LAR DEWAR  
CONDENSING COILS  
AT DØ

**SPECIFICATION AND REVIEW**

DØ Engineering Note  
3740.512-234, Rev. A

# LAr Dewar Condensing Coils

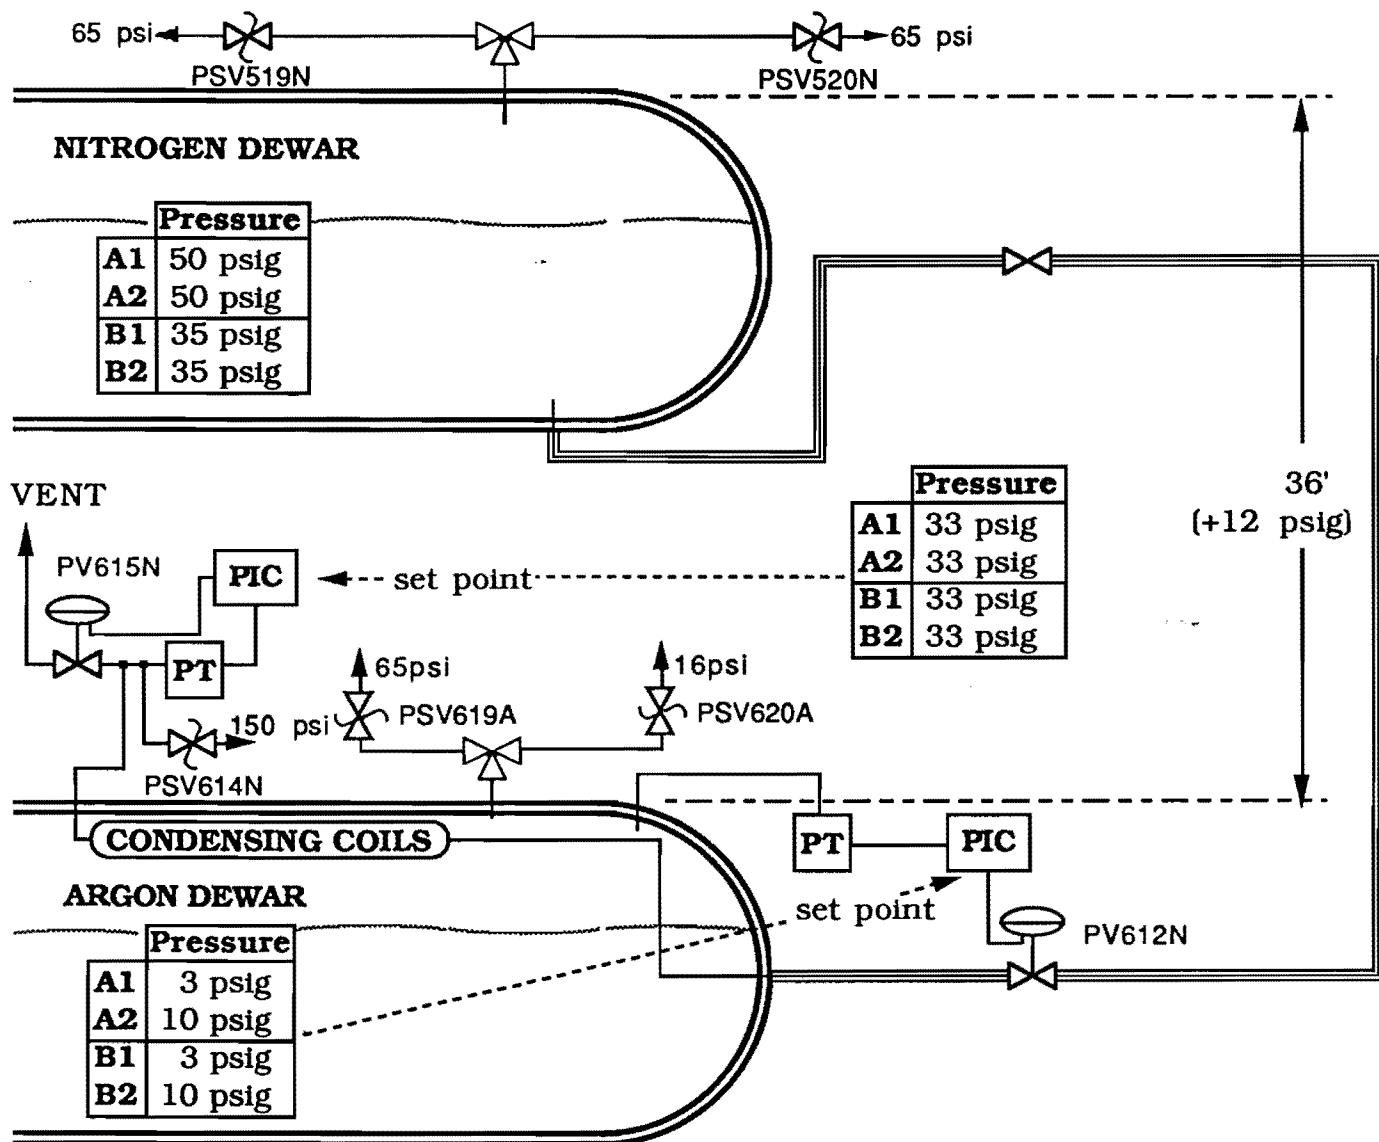
The safety committee has asked that we consider the catastrophic failure of the LN2 condensing pipes in the LAr dewar.

The presentations to date allow a quasi-static combination of LAr and LN2. That is a failure leads to a small but continuous LN2 flow onto the surface of dewar LAr. Because both fluids are constrained to have a common pressure, and the equilibrium nitrogen is colder by ca. 10k than the equilibrium argon, the LN2 gives up its heat of vaporization (ca. 200 j/g) to extract the LAr heat of fusion (ca. 25j/g). After a long time (total LN2 flow equal to 1/8 total LAr capacity) the LAr is frozen, and then cools to the LN2 equilibrium temperature. All this occurs at the limiting pressure of the 16 psig relief valve, i.e. at a final temperature of 83.4k. Beyond this point the LN can accumulate on top of the Ar and the vent scenarios provided apply.

If, instead, the cooling pipes fail catastrophically, the limiting flow of LN2 pours onto the liquid surface, immediately vaporizing, and providing a gas relief requirement (very quickly becoming) equal to the incoming mass flow. That will build pressure rapidly toward the 16 psig relief and cause the dewar to vent.

The flow is limited by the inlet valve ( $C_v = 1$ ) to ca. 4 gpm, for a 30 psig LN2 dewar and a 16 psig LAr dewar. That corresponds to  $M_{dot} = 26.6 \text{#/m}$ , or, at 2 atm., 48.3 acfm. At standard conditions, that is ca. 347 scfm.

The relief rating is 600 scfm (corresponding more if the flow is cold), the dewar vents periodically, and the process progresses toward the vent scenarios already provided as long as the LN2 holds out.

# Diagram A: Dewars/Coils Configuration

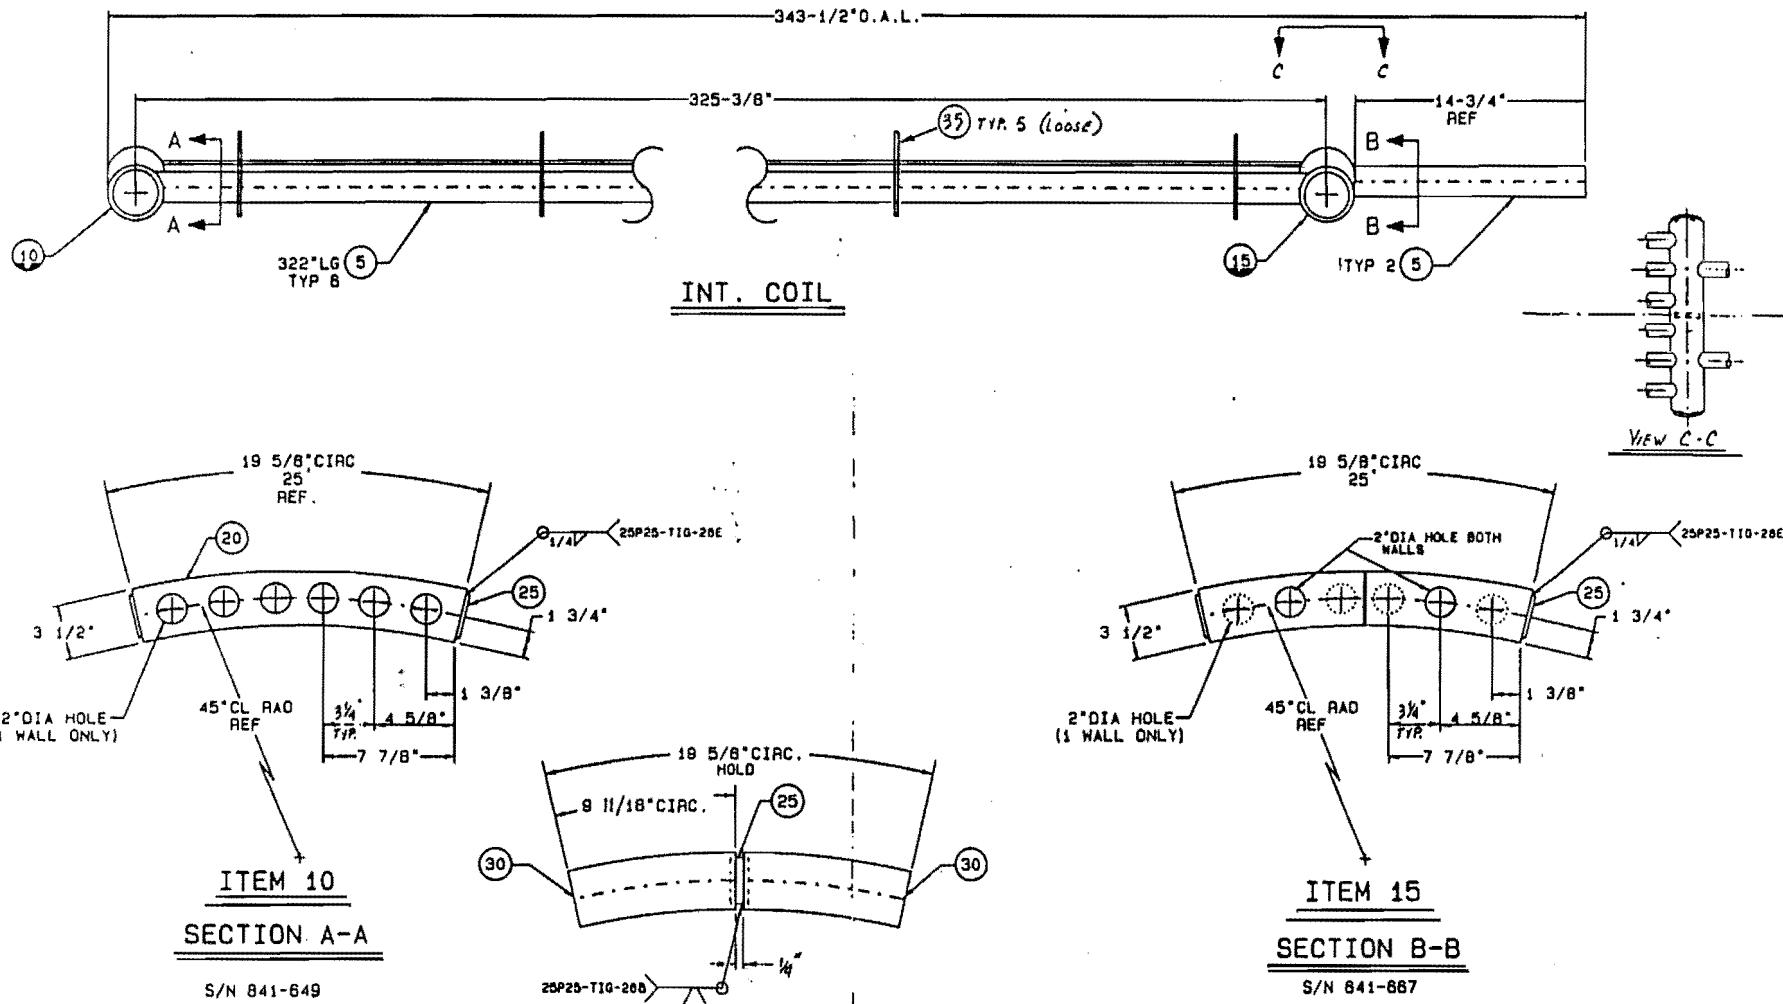
As always, it is prudent to anticipate worst case scenarios, and to circumvent any problem that may occur. In the case of the condenser, the worst that can happen is condenser coil failure allowing nitrogen to flow directly into the argon dewar. The nitrogen supply could be at 50 psig (maximum cooldown value, typical is 35 psig) with an added pressure due to the elevation difference. This added pressure is equivalent to the product of the height differential between the liquid levels in each dewar (see diagram A) and the density of the fluid. Thus it is at a maximum only when the liquid nitrogen dewar is completely filled. (The argon dewar would always remain full until the nitrogen dewar emptied).

When the 65 psig argon dewar relief is selected, it will not lift and the errant nitrogen flow will cease at the equilibrium pressure. Note that the condenser outlet valve will try to limit the condenser pressure to, typically, 33 psig and vent heavily. The argon dewar pressure, the nitrogen flow rate and rate of level change alarms will flag the problem. If the condenser outlet is closed, any subsequent gas generation will vent
